RS-03-115

Dresden Nuclear Power Station, Units 2 and 3
Facility Operating License Nos. DPR-19 and DPR-25
NRC Docket Nos. 50-237 and 50-249

Subject: Additional Information Regarding the Request for License Amendment Related to Heavy Loads Handling

Responses to NRC Questions

REACTOR BLDG. FRAMING PLAN, EL. 613'-0", SOUTH AREA

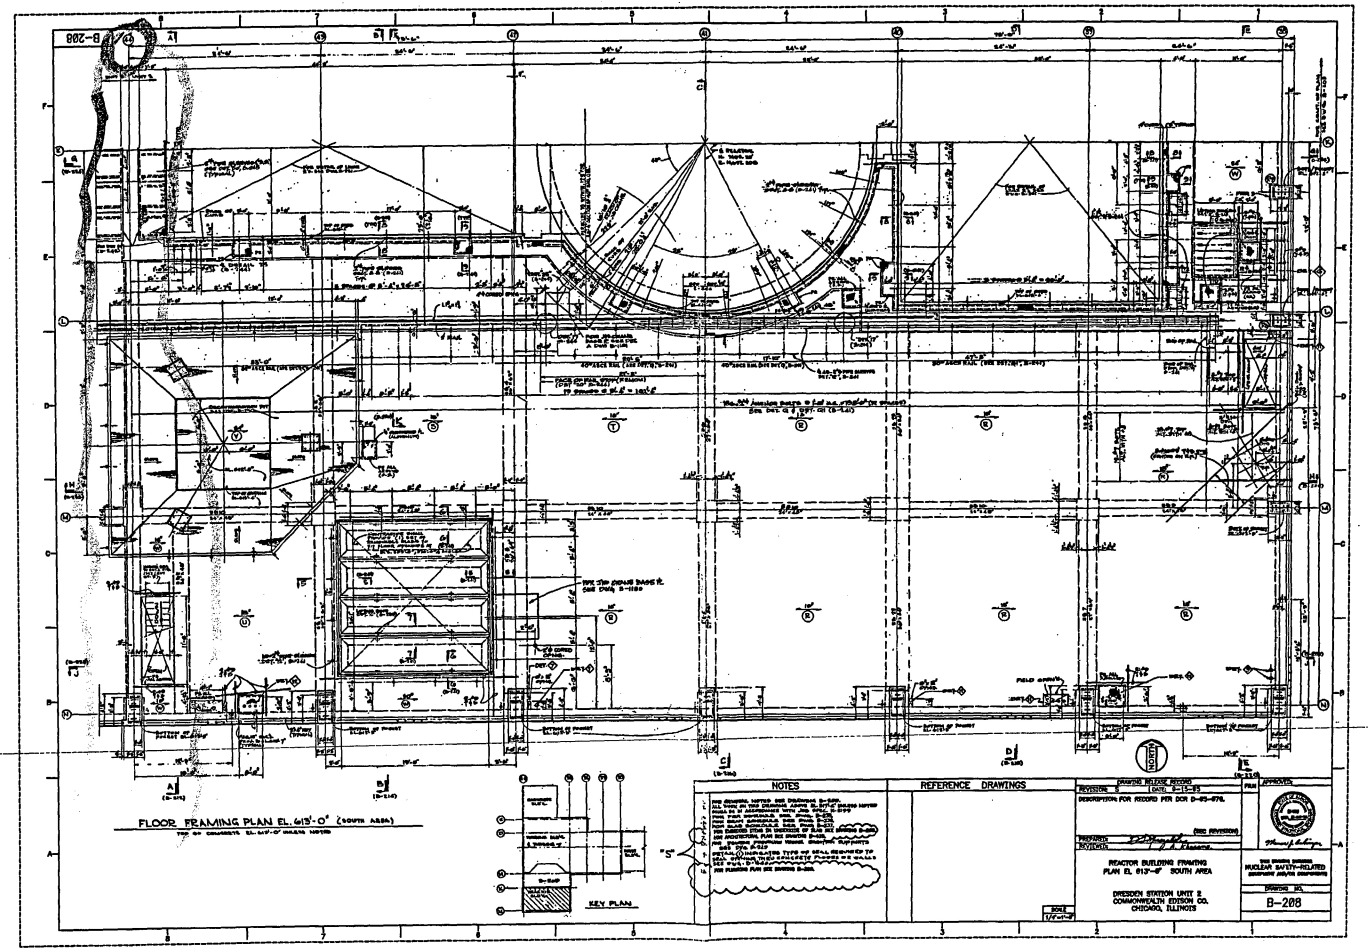
Question 3
The full drop of a shield plug on a system of two adjacent slabs with a beam in between the slabs, is analyzed as Scenario 3 of the load drop analysis. In this calculation the combined beam and slab moment resistance factor, as discussed on page 68 of 95, is obtained on the basis of an equation provided on this page. Provide an explanation of how this equation reduces the beam moment resistance that accounts for the area of the two adjacent slabs as indicated.

Response to Question 3
Beam 5B6 flexural resistance is calculated on pages 52-56 of Reference 2 (see attached drawing B-208). This beam supports two identical slabs, one on each side. The slab flexural resistance is calculated on pages 62-66. The slab flexural resistance is computed on the basis that beams exist on all the four sides to resist the reactions of the loaded slab. For each of the two slabs, the beams are available to resist the reactions from three sides. The fourth side of each of the two slabs is resisted by beam 5B6. Therefore, this part of the slab resistance must be subtracted from the beam total resistance. This part amounts to one-fourth of the resistance of each slab.

Based on the sizes of the end restraint members for the wall at Column Row 44 (Reference 2, pages 87-90), and the fact that the wall ends at plant elevation 613'-0" (see attached drawing B-208) and is continuous at elevation 589'-0" (see attached drawing B-226), the wall was considered to have "one end unrestrained and the other end restrained."

REACTOR BLDG. FRAMING SECTION C-C, UPPER AREA UNIT1"

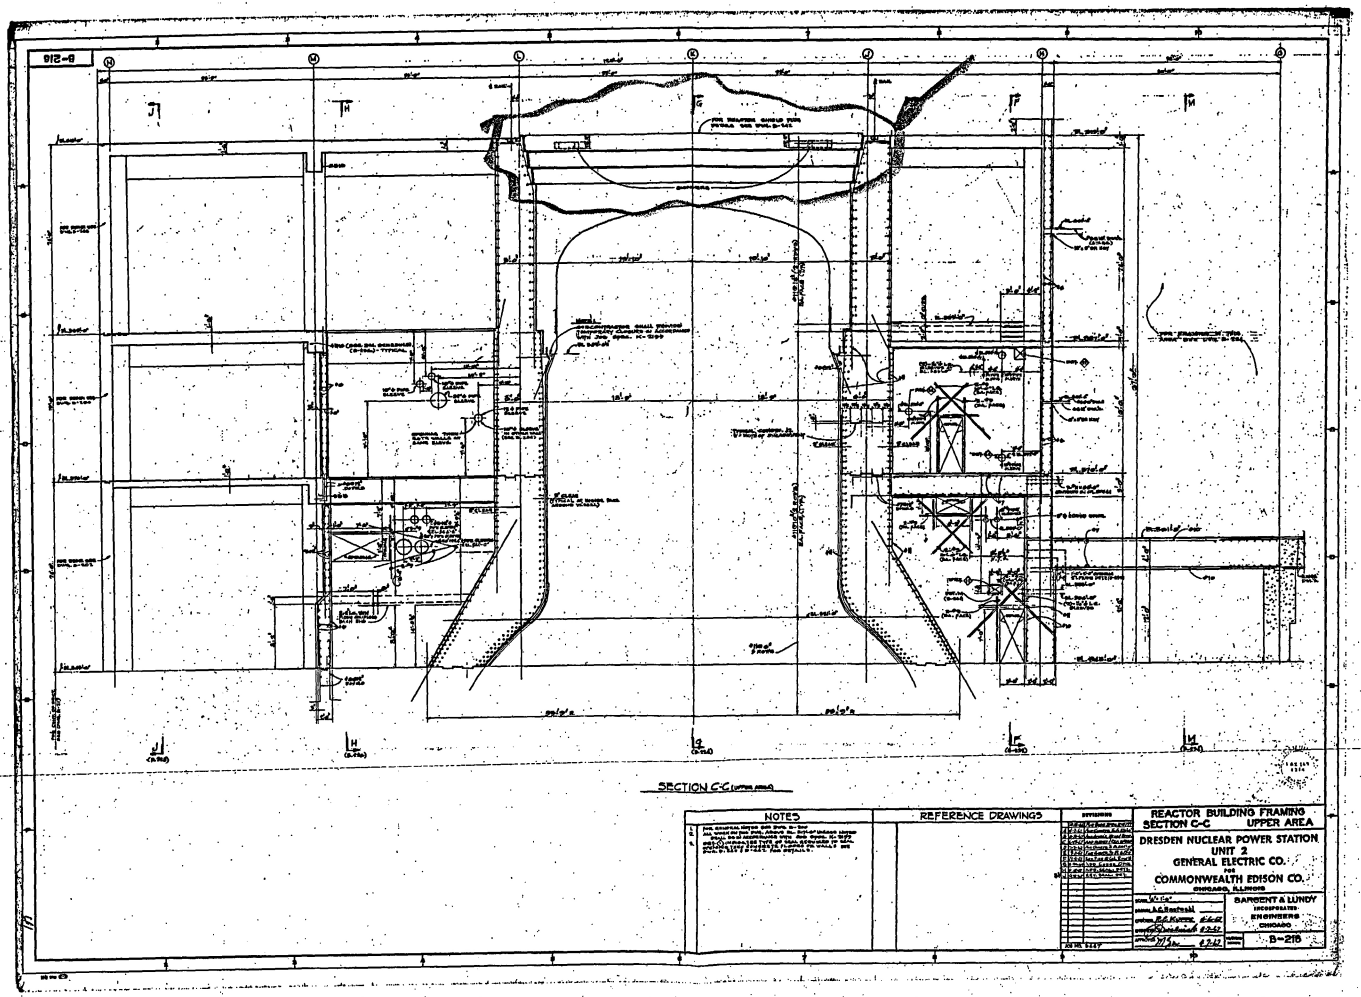
Question 5
Provide a drawing or illustration of the maximum height that a top shield plug can drop and explain why this height is the maximum possible drop height.

Response to Question 5
Attached drawing B-216 (Section C-C) shows the three layers of the shield plugs located over the reactor cavity before the top shield plug is lifted.

Pages 28 thru 37 of Reference 2 provide the analysis for lifting of the shield plugs (including top layer plugs) above the reactor cavity, for a height of up to 1'-0" above the floor at elevation 613'-0". Therefore, the load drop of the top layer shield plugs, from a maximum height of 1'-0" above the floor level at the reactor cavity, has been analyzed.

REACTOR BLDG. FRAMING SECTION H-H, UPPER AREA UNIT-2

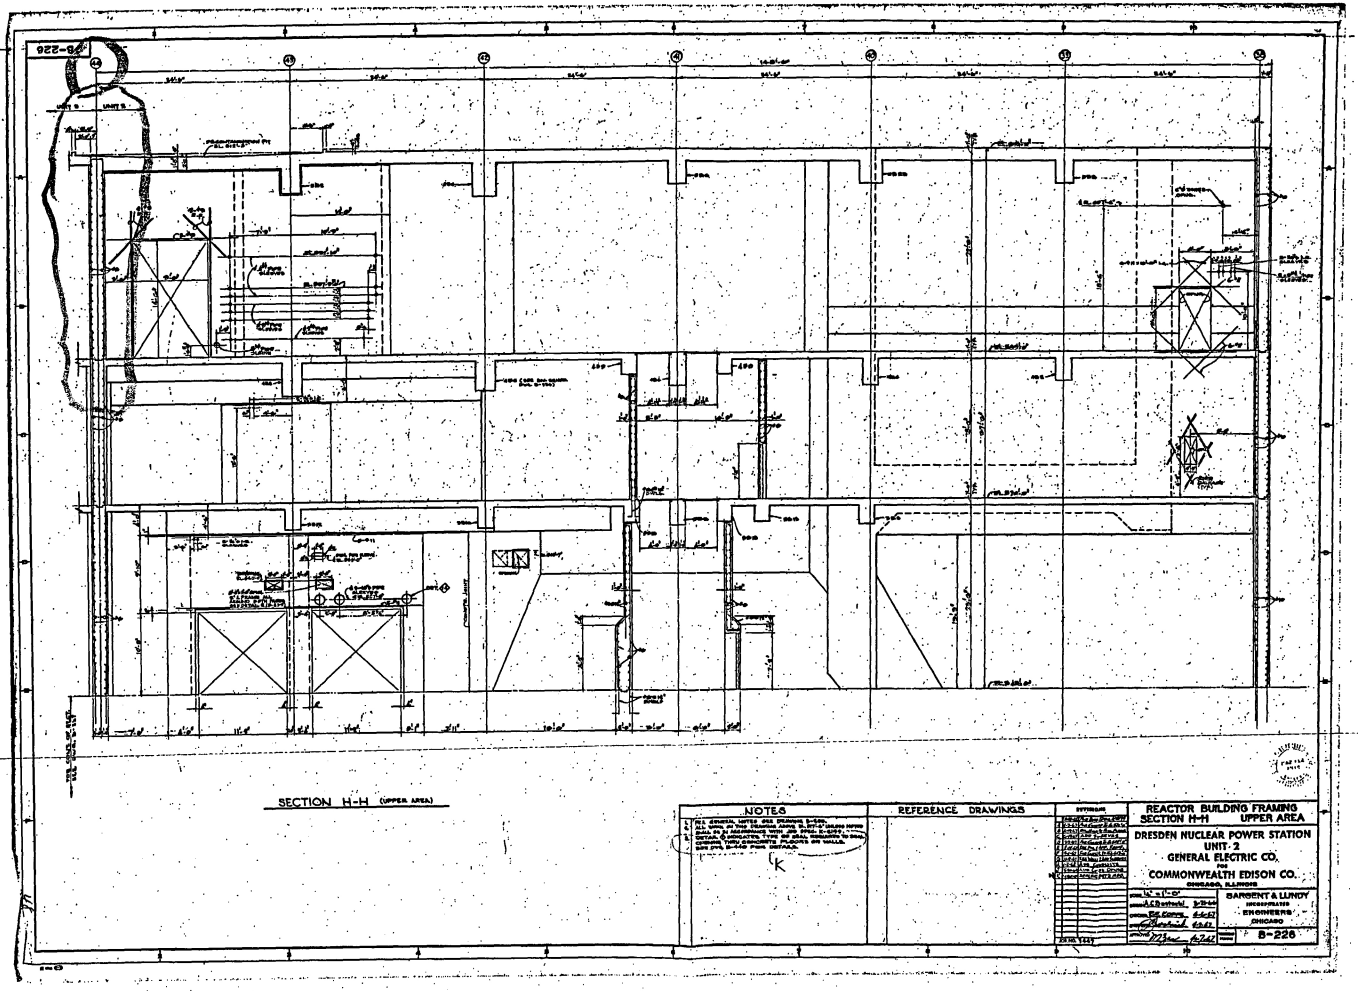
Question 4
The full drop of a shield plug on wall at column 44 is analyzed as Scenario 5 of the load drop analysis. Provide a definition of the factor "Kwall = 0.8" used on page 89 of 95 of this calculation and explain how it is obtained.

For these end conditions, value of "K" on page 543 of Reference 3 is 0.7. This same value 0.7 is also shown as the theoretical "K" value in Reference 4 on page 5-135. However, this same table recommends using design value of 0.80 for "K" for these end conditions when ideal conditions are approximated. Accordingly, Reference 2 on page 89, conservatively considers the value of "Kwall" as 0.8.

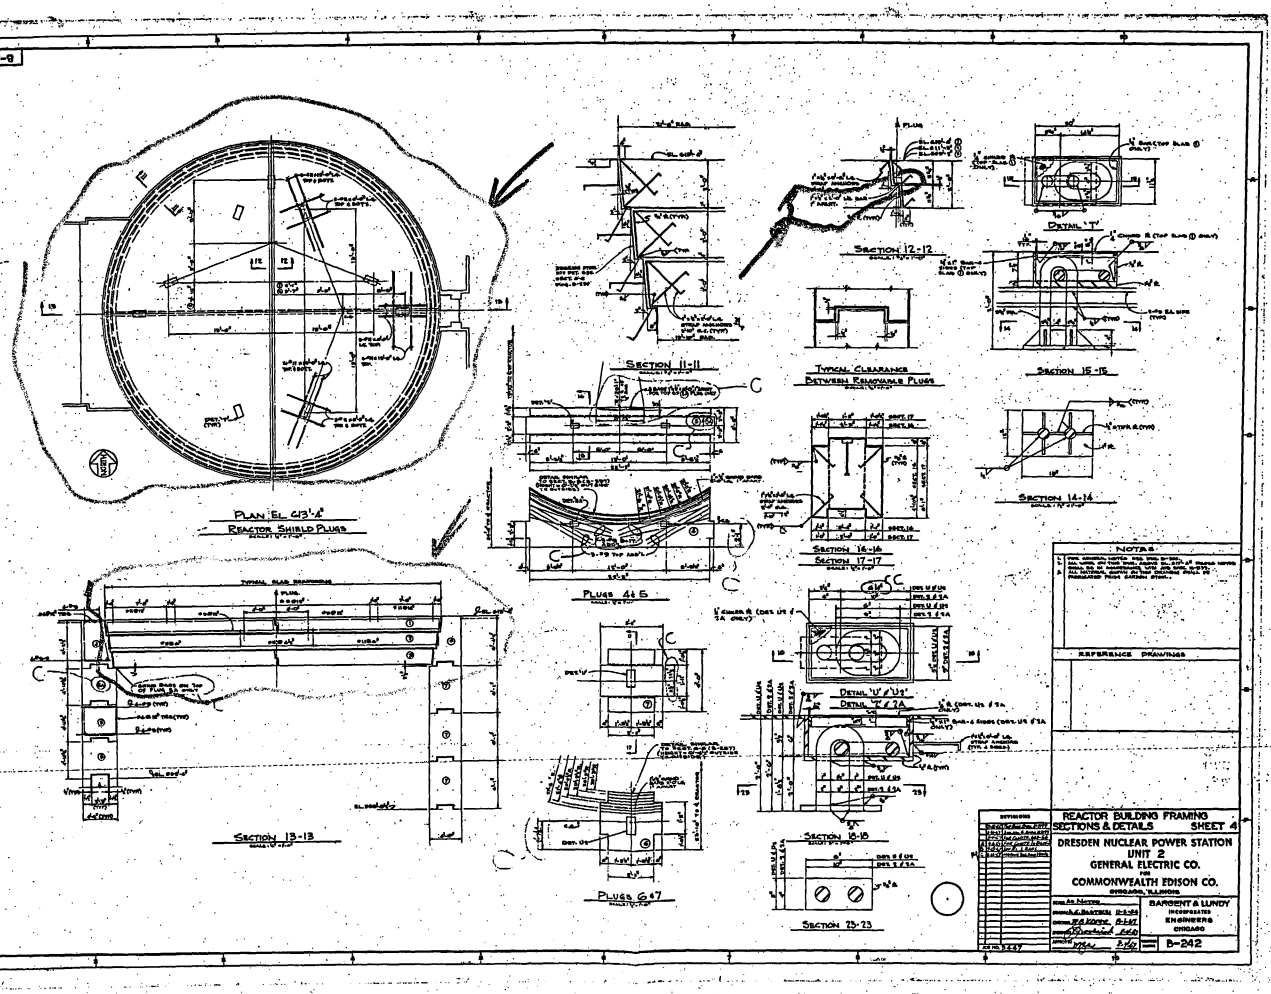
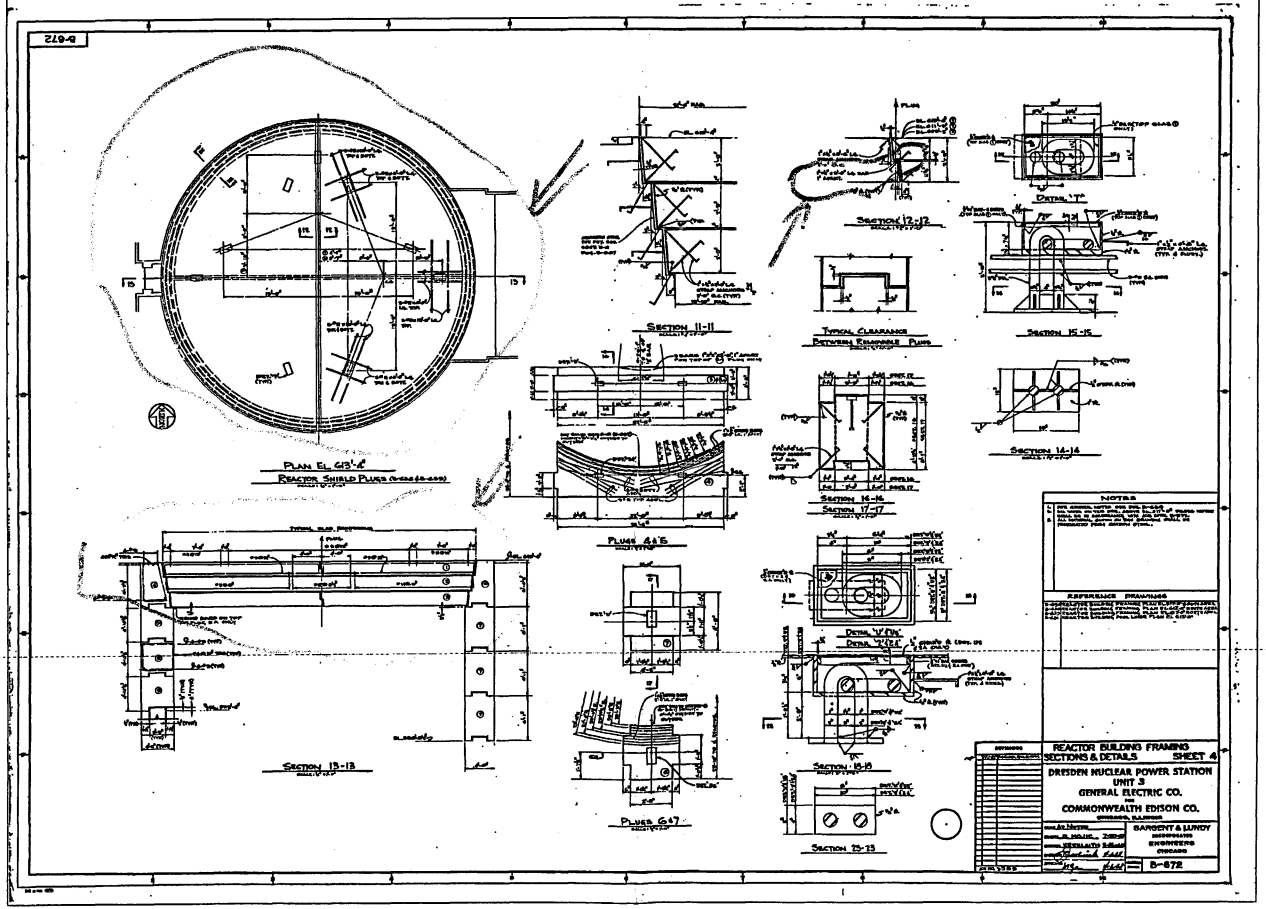
Question 1
The load drop of a shield plug during lifting of the plug from the cavity in Unit 3 and laying it down on top of Unit 2 shield plugs is analyzed as Scenario 1 of the load drop analysis (Attachment 3 of the amendment request). The calculations for determining the bearing capacity of the top shield plug on page 29 of 95, utilize a strength reduction factor of 0.7 for the bearing strength of concrete and a 2/3 factor to account for the spaces between the bearing bars. Provide the basis and applicable reference material for the use of this strength reduction factor and 2/3 factor.

2/3 Factor
As described on page 29 of Reference 2, the 2/3 factor is to account for the spaces between the bearing bars. It is also mentioned on page 29 that the bearing bars are 1" x 24" and the space between the bars is 12". This assumed spacing is conservative compared to the spacing of 1" between the bars shown in Section 12-12 on the attached drawings B-242 (Unit 2) and B-672 (Unit 3).

Therefore, as the bearing bars are not continuous (for the full length) and the calculation considers a space of 12" between them, on page 29 the factor of 2/3 is used to arrive at the reduced bearing strength of the concrete of the top plug (half circle). This is a conservative factor, given that the spacing between the bars shown on the drawings is 1".
